AMENDMENTS TO THE DRAWINGS

REMARKS

FIG. 4

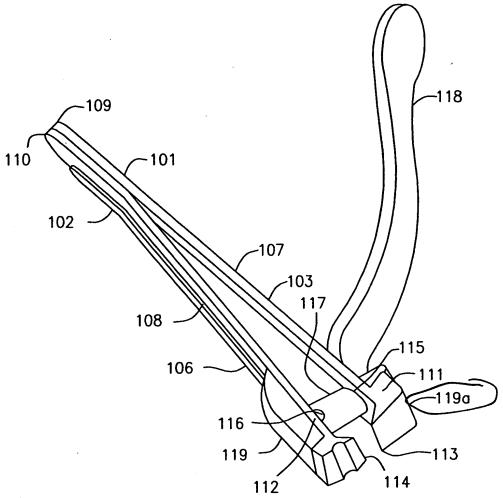
A Figure 4 revised (also corrected to show 119a) as requested by the Examiner is submitted herewith.

FIG. 5

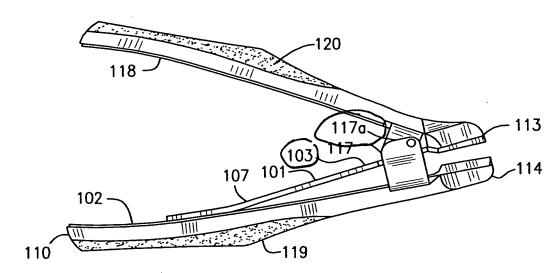
As the Examiner has apparently recognized, Figure 5 is a side view rather than a perspective view. The specification has therefore been corrected. Also, corrected drawings are being submitted for entry after approval of the Examiner. As a result, it is respectfully submitted that the objection to the drawings, objection under rule 1.71 and rejection under 35 USC §112, first paragraph, can now be withdrawn.

Figure 5 shows top member 101, bottom member 102 and post 117. A corrected figure is submitted herewith on which designations the top surface 103 of top member 101, and the top (117a) of the post 117 have been added. It can readily been seen that the top of the post 117a is above the top surface 103 of top member. Since this is a side view and Figure 6 is a top view, it is apparent that cutting edges are at an angle to the central longitudinal axis, and how the members and post interact is apparent. While it is also apparent that the other side can have a similar post, claim 18 has been cancelled in order to moot the issue as to a second post.
